Supplement PD-373 Connecting new illuminated 216 Keypad

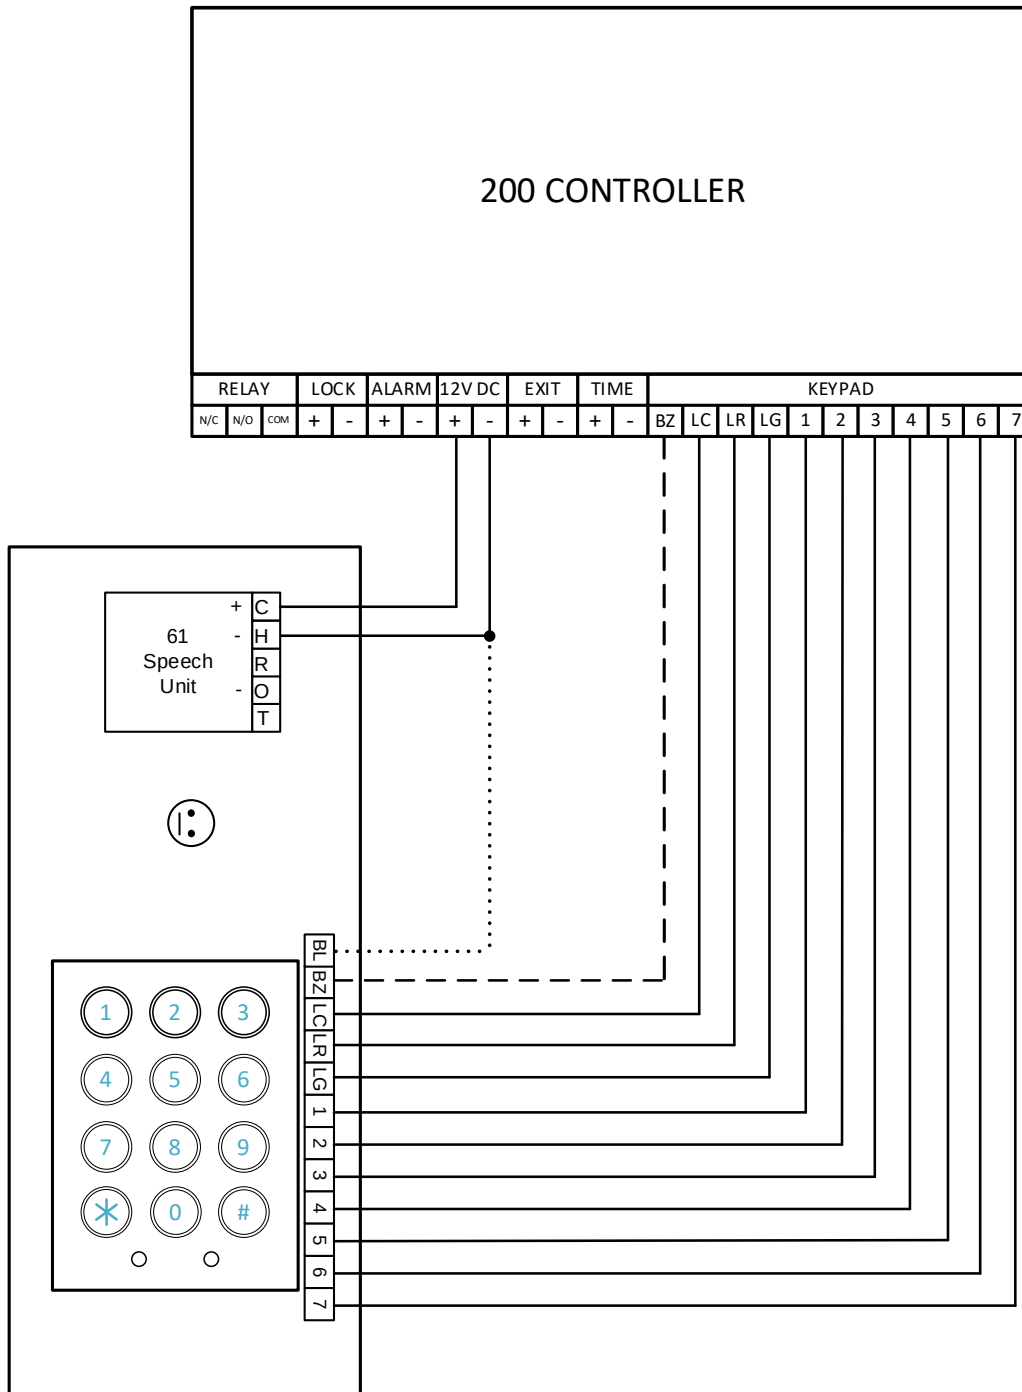
The New 216 has both the BZ and BL terminals fitted as standard.

The BZ on the Keypad should be connected to the BZ on the 200 controller to enable the tones from the keypad

The BL terminal is to illuminate the Keypad back light, this needs to be connected to a permanent negative. This can be connected to the 12V- on the controller or the H- on the speech unit.
100mA @12vDC
